**Addendum No.: 1**

**Quote #: 26-20-1**

**Project Name: Lafitte St Drainage**

Attachment G - Revised

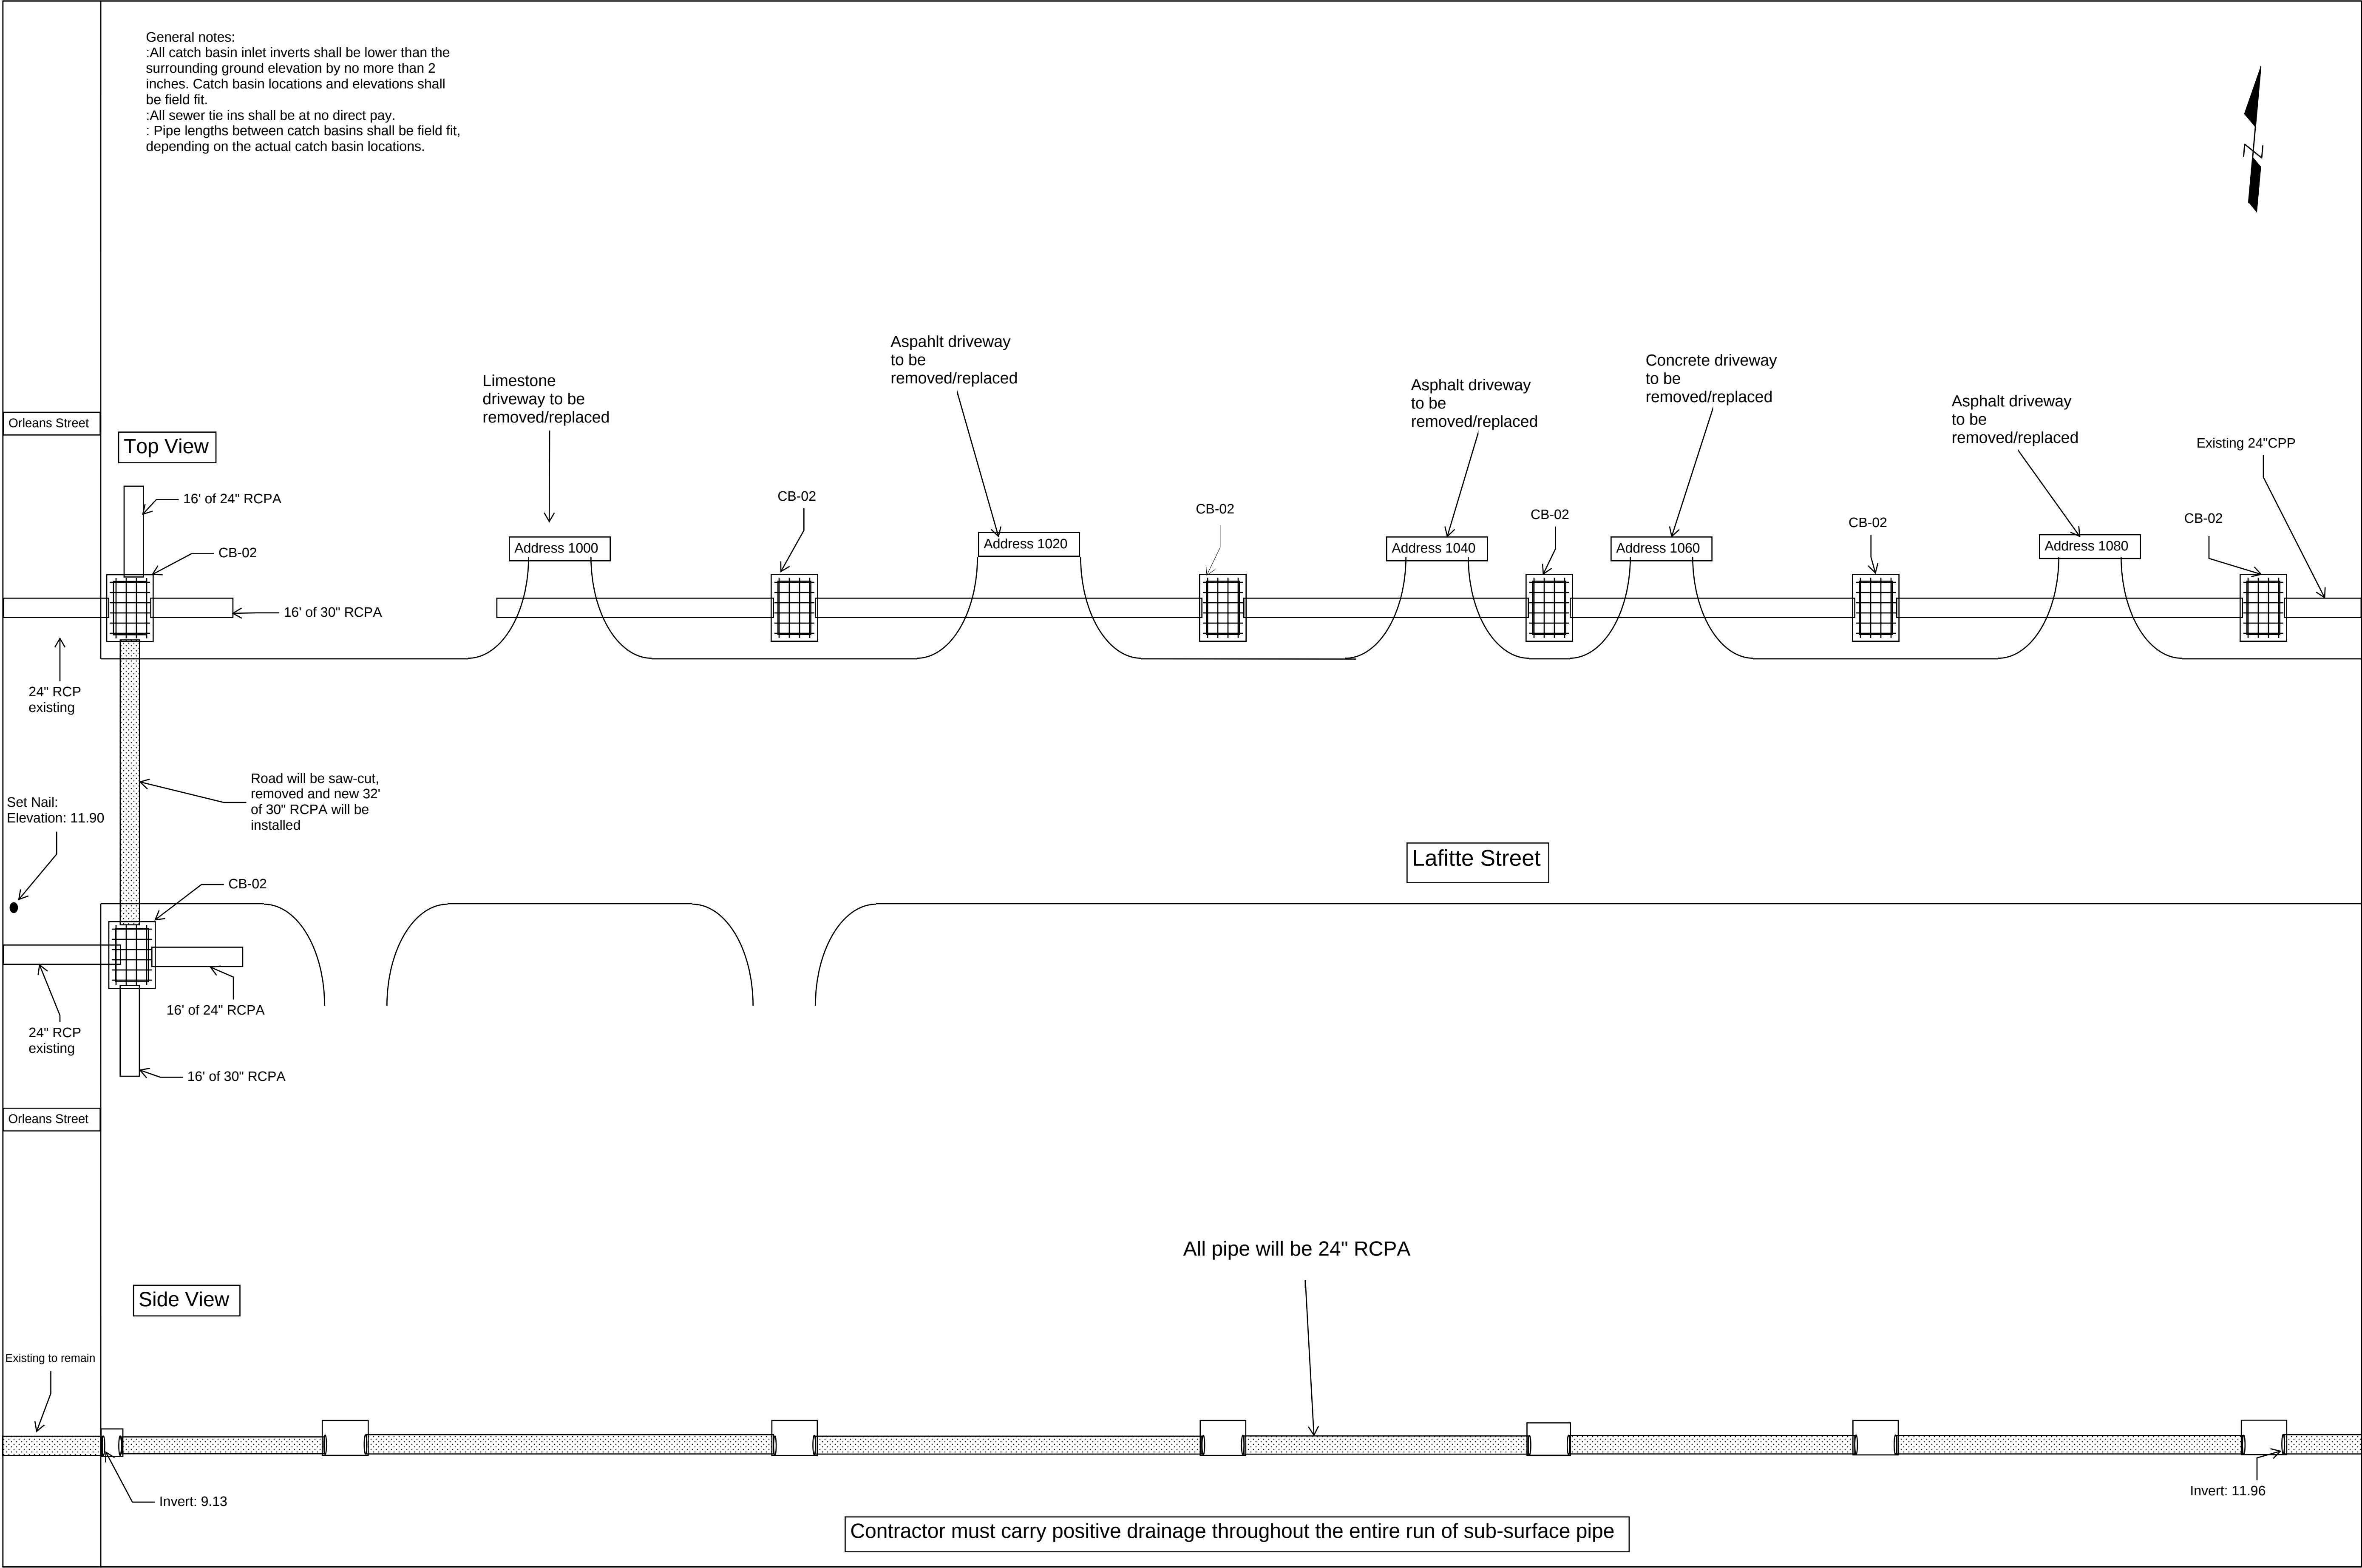
1. Please remove Attachment G – Layout and replace it with Attachment G- Layout – Revised (attached).
2. Please remove Attachment A – Unit Price Sheet and Attachment A – Project Specifications and replace it with Attachment A – Unit Price Sheet and Attachment A – Project Specifications – Revised (attached).
3. Please add Attachment H – Sewer Layout to the package.

Question 1. The layout plans call for all catch basins to be CB-01 while the unit price form calls for the catch basins to be CB-02. Which would be necessary for the project?

Question 3. The Unit Price Form calls for (8) Catch Basins while the provided plans only show (7). Is the 8th catch basin extra or is there a spot for it to be installed.

**Answer 1. Please refer to General Information #1.**

**Answer 3. Please refer to General Information # 2.**

### SEWER EFFLUENT PIPE TIE-IN

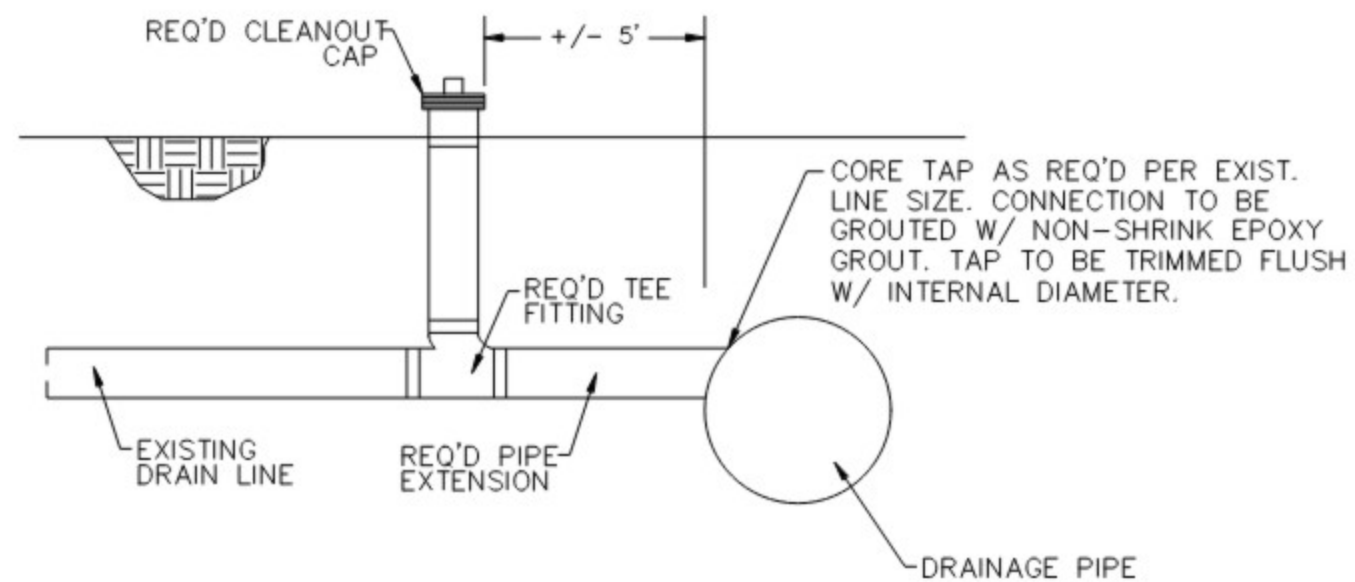
Question 6. On Attachment G, a footnote describes sewer tie-ins at no direct pay. Do you have a detail of these sewer tie-ins or is it a general note that is not applicable to this job?

**Answer 6. Please refer to General Information #3.**
